PROJECT: Leewood Village at North Rock

STAFF REPORT
(Preliminary Plat)

CASE NUMBER: S/D 91-64 - LEEWOOD VILLAGE AT NORTH ROCK ADDITION

STAFF REPORT
(Final Plat, Preliminary Plat Approved 1/2/92 by MAPC)

VICINITY MAP:

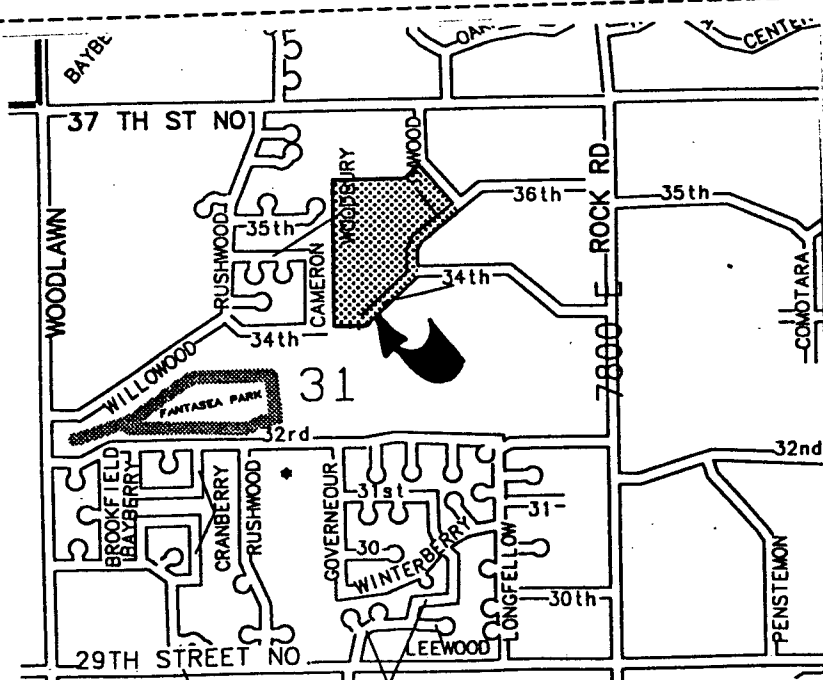
- A. The applicant shall guarantee the extension of sanitary sewer to serve the lots being platted.
- B. The applicant shall guarantee the extension of City water to serve the lots being platted.

- C. The applicant shall guarantee any drainage improvements required by the platting of this property.
- D. The applicant shall guarantee construction of the storm sewers required by this plat.

- E. The applicant shall guarantee the paving of the proposed interior streets. The guarantee shall include the installation of sidewalk on both sides of 34th Street North/Inwood. This street is being developed as a collector and sidewalk is required on both sides of collectors. This street shall also be paved to the collector standard.

- F. Since 34th St./Inwood has been platted by previous additions, City Engineering and the applicant both need to indicate the situation involving this street segment. Specifically, are existing guarantees to be used for this street's paving (and sidewalks) or are new petitions or guarantees to be provided?

- I. On the final plat, Governour/35th St. North shall be platted with a 64 foot right-of-way. According to the Subdivision regulations, streets with 58 foot rights-of-way are typically used for culs-de-sac of less than 600 foot lengths or for continuous streets with not more than 24 lots per block and streets that are not more than 3 blocks long. By definition, a block is also considered to be a street segment bordered by other (continuous) street segments. A cul-de-sac itself does not break up a street segment as a block, but rather adds to the number of lots and therefore traffic potentially passing through the main street segment.

- L. The applicant shall provide proof, by letter or by copy of the pipeline easement agreements, that the pipeline easement as shown is sufficient and that utilities may be located adjacent to and within the easement. Any relocation, lowering or encasement of the pipeline, required by this development, will not be at the expense of the City.
- M. On the final plat additional dimensions shall be provided for the utility easement at the rear of lots 8 and 9, Block 2.

- N. Prior to or at the time of submitting the final plat, the applicant shall submit a drainage plan to City Engineering for review and approval.
- O. Requirements for a final plat (see pages 24-29, Part 4, Article 5 of the MAPC Subdivision Regulations).

VICINITY MAP:

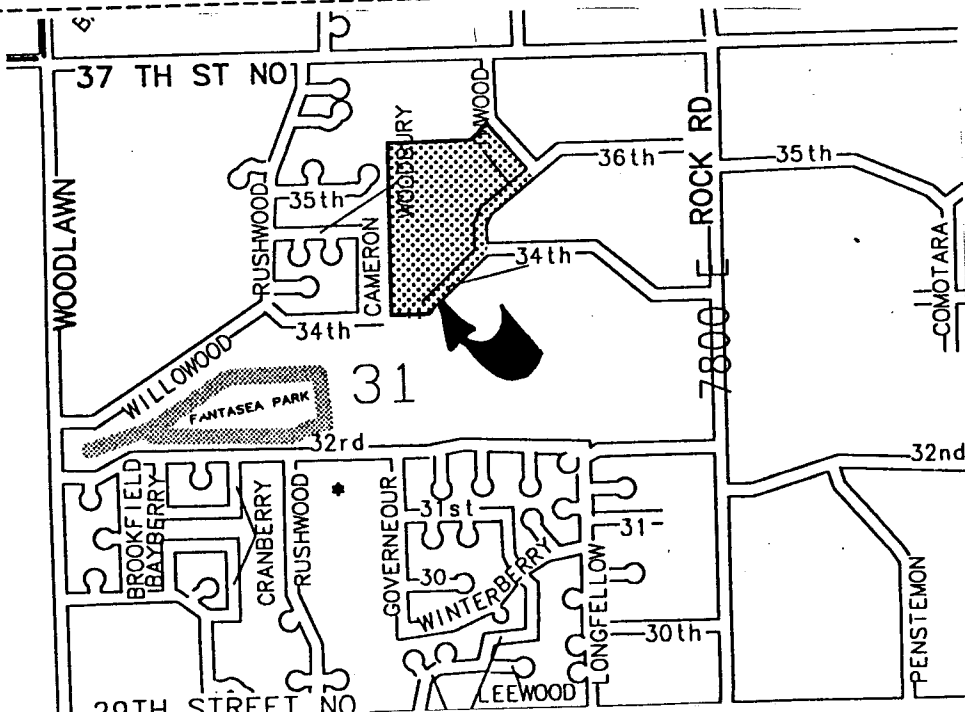
- F. The applicant shall submit a covenant which provides for four (4) off-street parking spaces per dwelling unit on each lot which abuts a 58-foot street. The covenant shall inventory the affected lots by lot and block number and shall state that the covenant runs with the land and is binding on future owners and assigns.

- G. The applicant shall provide proof, by letter or by copy of the pipeline easement agreements, that the pipeline easement as shown is sufficient and that utilities may be located adjacent to and within the easement. Any relocation, lowering or encasement of the pipeline, required by this development, will not be at the expense of the City.

- H. As was noted during review of the preliminary plat, on the final plat additional dimensions need to be provided for the utility easement at the rear of lots 8 and 9, Block 2.

- I. As was indicated on the preliminary plat Governour should be indicated as a Circle and not a Court for its terminus on this Addition.
- J. Since a monument easement (reserve) is no longer being indicated for lot 44, Block 1, the dashed lines along the eastern corner of this lot shall be deleted from the final plat tracing.
- K. On the final plat tracing the MAPC signature block shall be amended to indicate Christopher J. Goebel as chairman.
- L. When the preliminary plat was reviewed, K.G. & E. requested a number of 10 foot utility easements. Unless indicated otherwise by K.G. & E. the following easements shall be indicated on the final plat tracing along the common lot lines of:
